HISTORIC AND DESIGN REVIEW COMMISSION

HDRC CASE NO: 2017-169
ADDRESS: 720 LAMAR ST
LEGAL DESCRIPTION: NCB 1653 BLK A LOT 10
ZONING: R-5 H
CITY COUNCIL DIST.: 2
DISTRICT: Dignowity Hill Historic District
APPLICANT: Dan Plummer/North Gate Custom Builders LLC
OWNER: North Gate Custom Builders LLC
TYPE OF WORK: Construction of a single family house
REQUEST:

The applicant is requesting conceptual approval to construct a single family house featuring approximately 1,730 square feet on the vacant lot at 720 Lamar in the Dignowity Hill Historic District.

2 RIGHT ELEVATION
A4 SCALE: 1/4" = 1'-0"

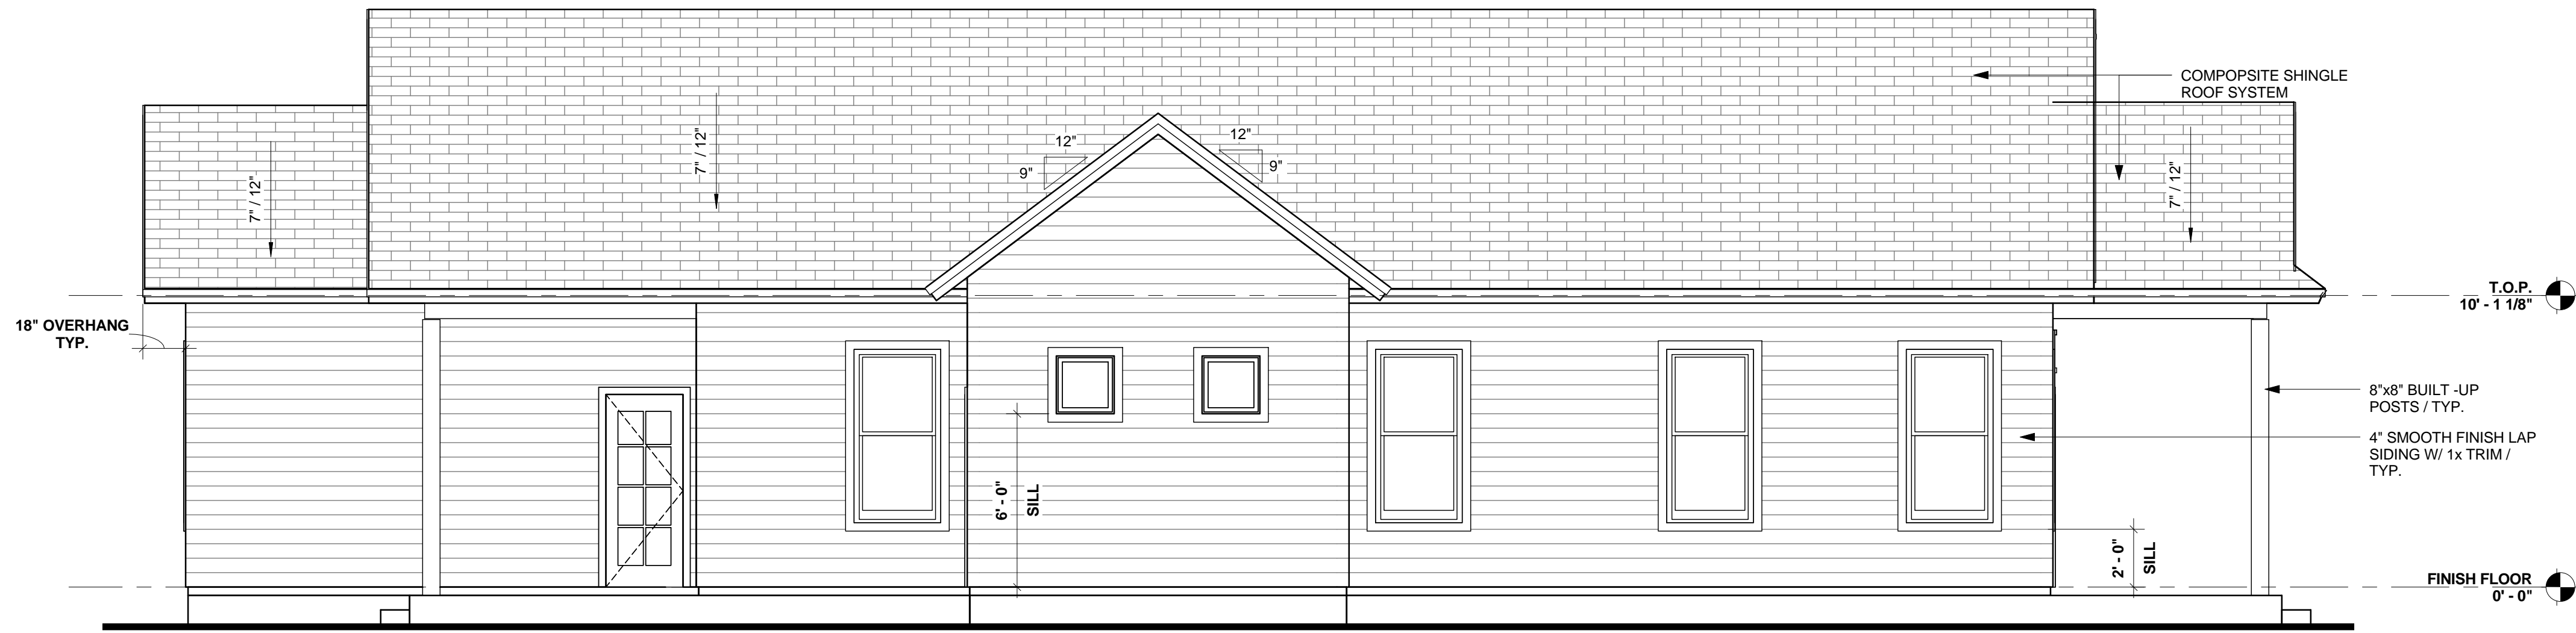
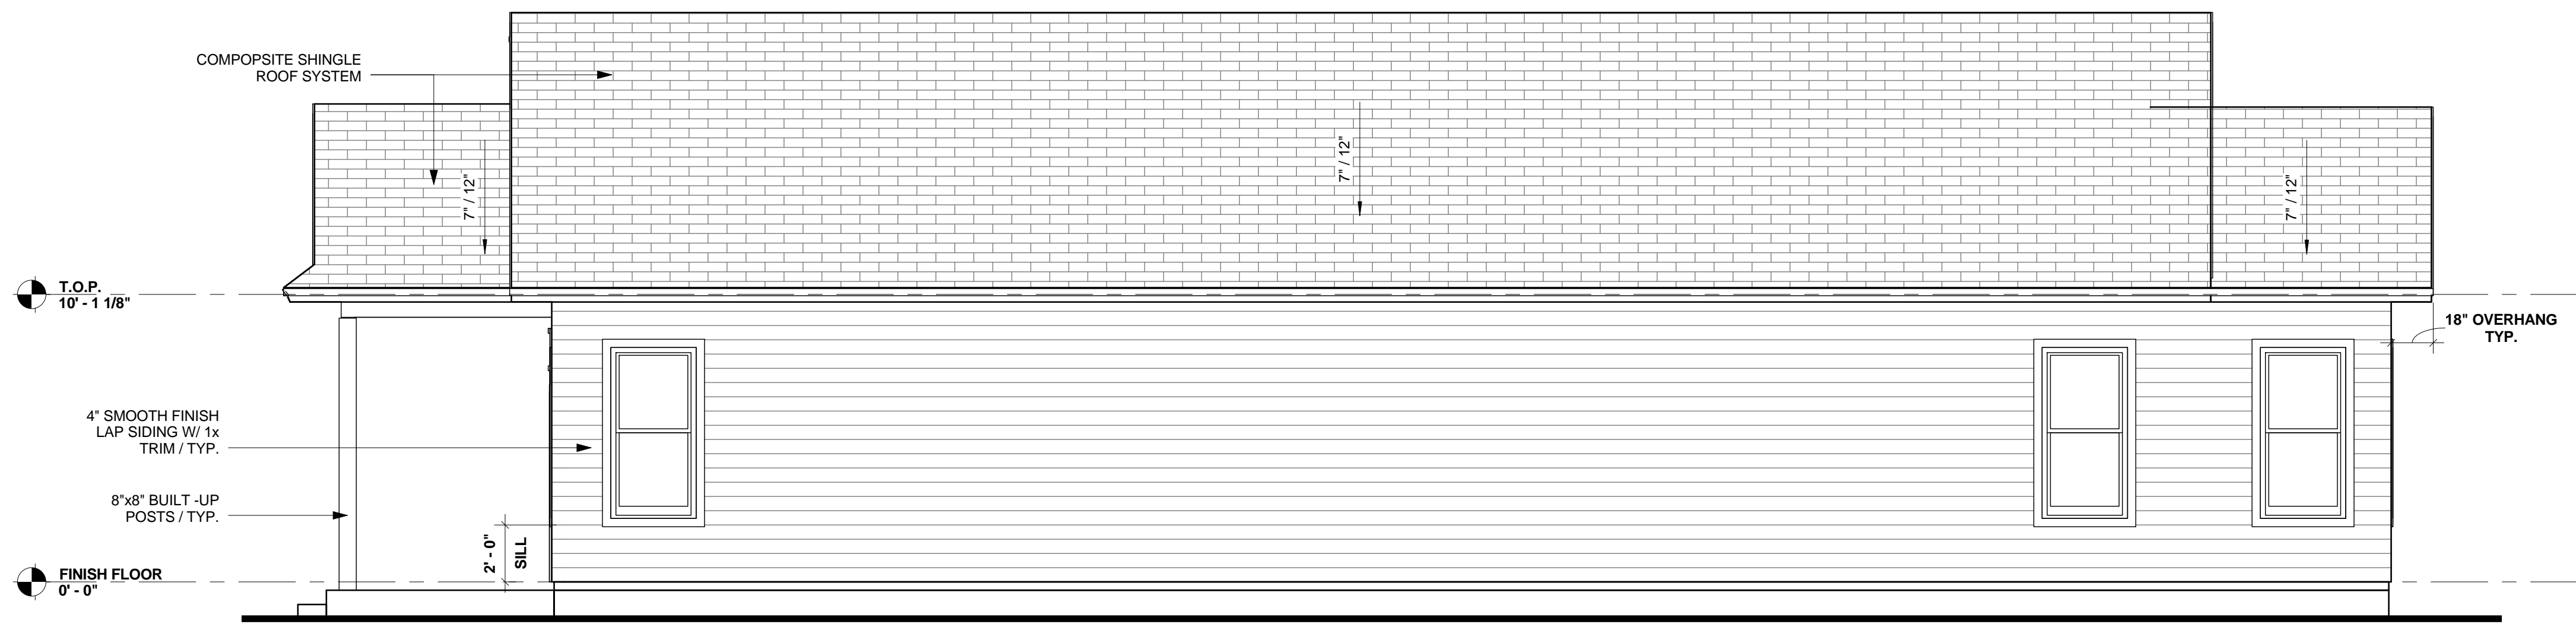
- j. WINDOW & DOOR OPENINGS – On the left elevation, the applicant has proposed window openings that are generally consistent with the Guidelines. The applicant has proposed an extending bay which currently features no window openings. Historic structures that feature a bay have windows incorporated into those bays. Staff recommends the applicant install windows in the side window bay that are consistent in height with those found on the left elevation.

- k. WINDOW & DOOR OPENINGS – The proposed right elevation is currently void of window openings with the exception of three small fixed windows. This is not consistent with the Guidelines for New Construction 2.C.i. Staff finds that window openings that are sized and located similar to those on the left façade should be installed.

- iii. That the applicant install windows in the side window bay that are consistent in size with the other left façade windows as noted in finding i.
- iv. That the applicant install wood windows that are consistent with the Historic Design Guidelines, Window Policy Document as noted in finding n that are to include traditional dimensions and profiles, be recessed within the window frame, feature traditional materials or appearance and feature traditional trim and sill details as noted in finding l.
